ROC GC Log Addenda – 3/7/23

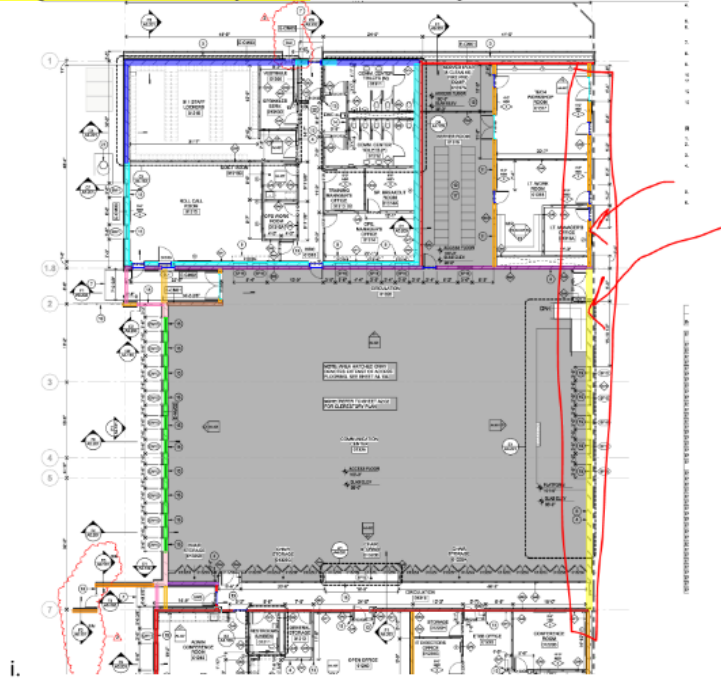
15.)Q: Door #01410B appears to be missing from the door schedule. This is the door tied to elevation CW7.

R: **This is addressed in Addendum #4.**

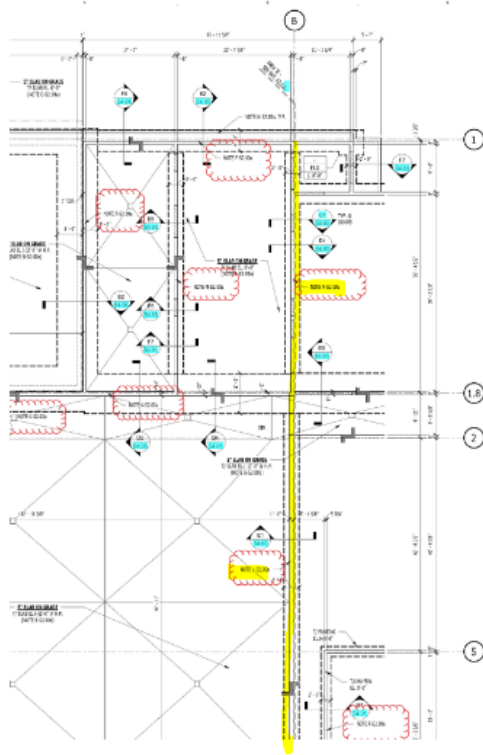
16.)Q: From Public lobby room 01110 into open office 01420, there is a window tagged 'W1'. I cannot seem to locate this window on any schedule. Please advise what is needed for this location?

R: **This is addressed in Addendum #4.**
